NORTHWEST FLORIDA WATER MANAGEMENT DISTRICT

Statewide Environmental Resource Permitting
Rules for Stormwater Design and Operation
Regulations Rule Development Workshop for
Applicant's Handbook
Volume II, Appendices, and References and
Design Aids

The NFWFMD's ERP Applicant's Handbook Volume II (ERP A.H. Vol. II)

Section 4.8 On-Line and Off-Line Stormwater Systems

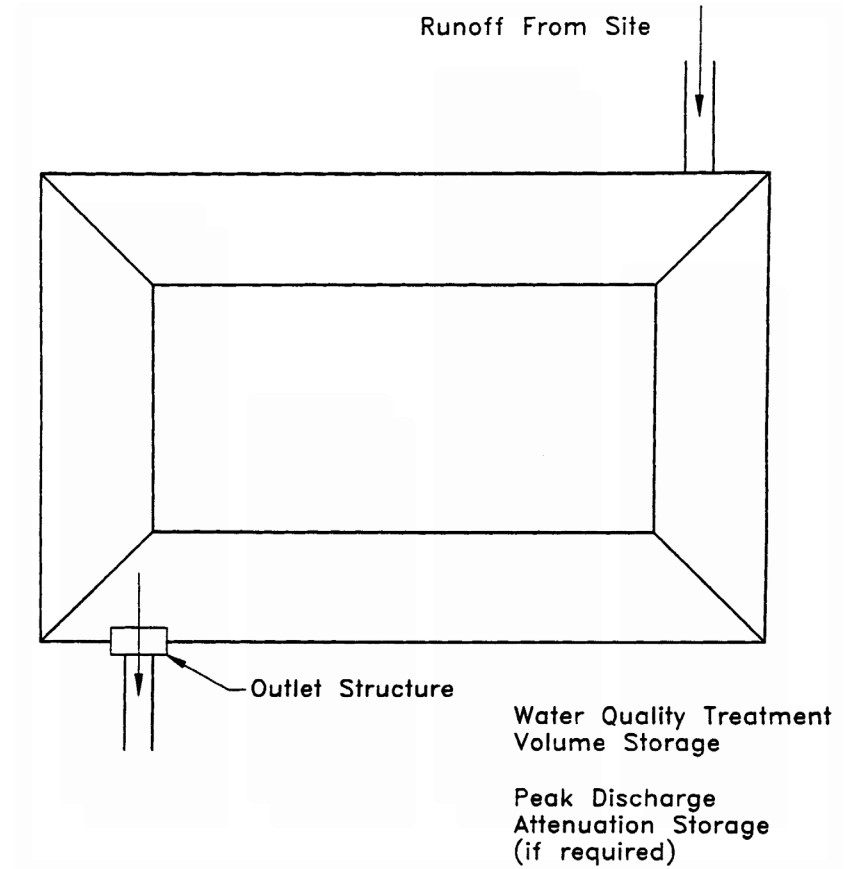
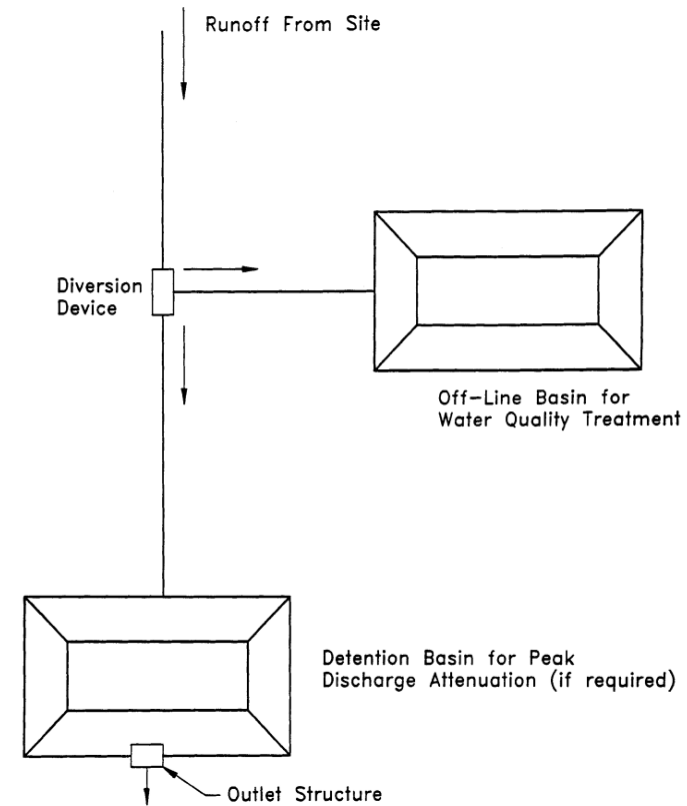
Section 4.8 (now Section 4.6) ERP A.H. Vol. II was revised to further address BMP trains.

- On-Line Systems – No Change
- Off-Line Systems – Changes remove half (0.5) inch requirement and to address BMP Treatment Trains

Off-line system will no longer be based on the half (0.5) inch volume requirement.

Example of Off-Line System (No longer based on 0.5-inch "first flush" presumptive requirements)

Off-line systems are generally more effective at removing pollutants than on-line systems because accumulated pollutants cannot be "flushed-out" during storm events that produce runoff volumes exceeding the treatment storage volume. Consequently, on-line systems must treat a greater volume of runoff than off-line systems to reduce the likelihood of flushing accumulated pollutants out of the system and achieve the minimum stormwater treatment levels required by the Water Resource Implementation Rule (Chapter 62-40, F.A.C.). Treatment volumes for each of the stormwater treatment practices are discussed in **sections 5 through 12 of Part V of this Volume.**

The treatment storage provided in an off-line system can be considered in the stage/storage calculations for peak discharge attenuation. Off-line systems shall be designed to bypass essentially all additional stormwater runoff volumes greater than the required treatment volume to a discharge point or other detention storage area. Of course, there will be some incremental additional storage in the off-line system associated with the hydraulic grade line at the weir structure in the typical diversion structure. This will depend on the size of the weir, but the weir shall be sized to pass the design or excess flow with minimal headwater.

Proposed off-line systems that will also serve to provide significant detention storage above the required off-line treatment storage volume will be considered to function as on-line systems. These systems shall either be designed to meet on-line treatment volume requirements, or the designer registered professional must discuss the merits of the particular system (in terms of potential of flushing accumulated pollutants) with Agency staff in a pre-application conference. In such cases, an applicant must provide reasonable assurance that the on-line treatment volume is not necessary to meet the other applicable criteria for issuance.
